WASHINGTON METROPOLITAN AREA TRANSIT AUTHORITY
600 Fifth Street, NW, Washington, DC 20001-2651

AMENDMENT OF SOLICITATION / MODIFICATION OF CONTRACT

1. AMENDMENT/MODIFICATION A004		2. EFFECTIVE DATE November 9, 2017	
3. ISSUED BY PURCHASING SECTION Frederick R. Voellm JGB Room 301-G Department of Procurement		4. ADMINISTERED BY (If other than block 3)

QUESTIONS FROM INTERESTED VENDORS AND WMATA RESPONSES

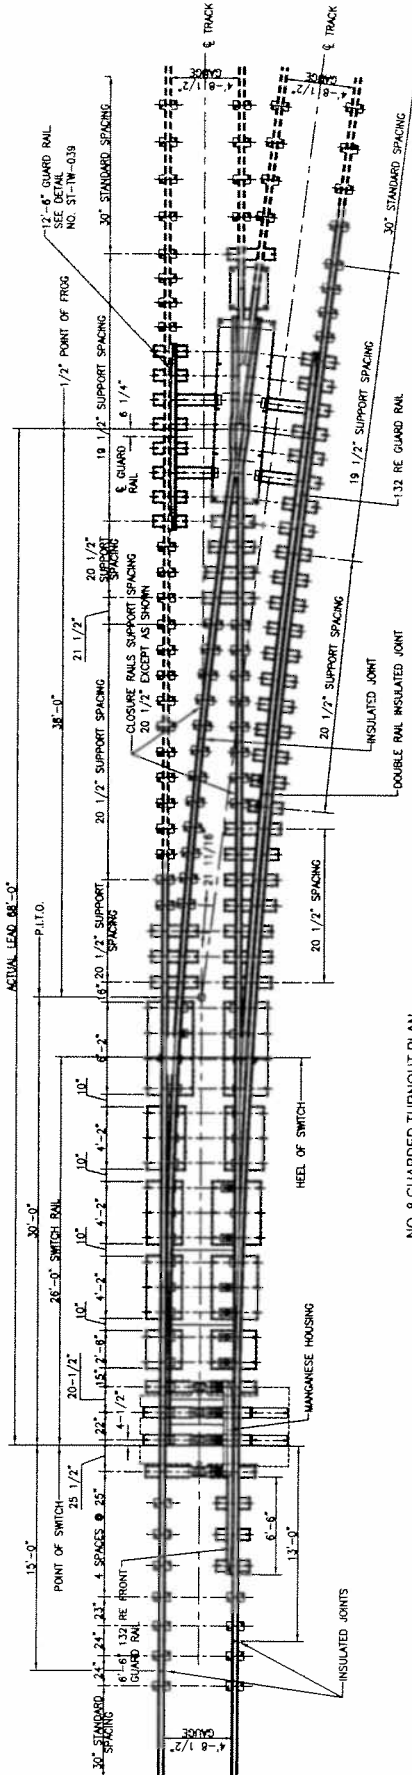
8. Two similar questions received from interested vendors with regard to Section 3.6.2 of the Scope of Work :

Q: Can you clarify exactly what is required for this inspection?

Q: Is 3.6.2 actually a requirement of inspection, or is this an error?

R: If there is a technical difficulty with the materials provided by the contractor, then the contractor will need to set up a mock switch panel at its facility so the WMATA inspection team can observe a test. One of the areas of concern is the AREMA "Samson Undertuck" where the switch point sets in the stock rail.
